文書番号: PCN\_J\_DIN\_1410  
2014年10月31日

## ERNI 社 DIN41612 コネクタ 材料変更のご連絡

PCN	Product Change Notification	De-14-08-0166	
Product	DIN 41612 / IEC 60603-2	Date of Publication:	
		30.07.2014

**Product:** DIN 41612 / IEC 60603-2 connectors (THR termination)  
Female Type B, B/2, B/3, C, C/2, C/3, CD, E48, Q/3, R, R/2, R/3, RD  
Male Type B, B/2, C, C/2, C/3, CD, D32, E48, E160, M, Q/2, Q/3, R, R/2, R/3, RD

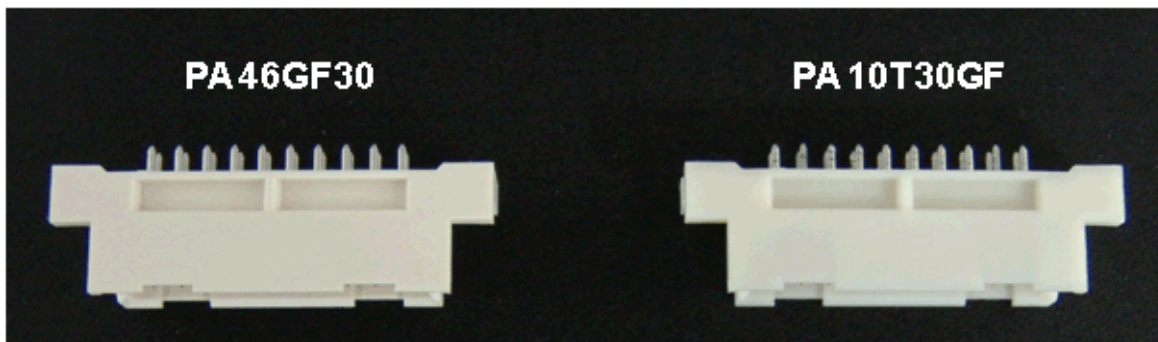
### Reason of Change:

Improvement of connector properties by the change of the plastic material.

in order to satisfy high customer requirements the plastic material of the above listed DIN 41612 / IEC 60603-2 connectors with THR termination has changed from PA 46GF30 to PA 10T30GF.  
The advantages of the new material are in particular improved Fire Protection Properties according to UL-Standard, better Moisture Sensitivity Level (MSL) and an excellent Comparative Tracking Index (CTI) of 600.

This change will not affect reliability of product and has no impact on form, fit or function of these connectors.
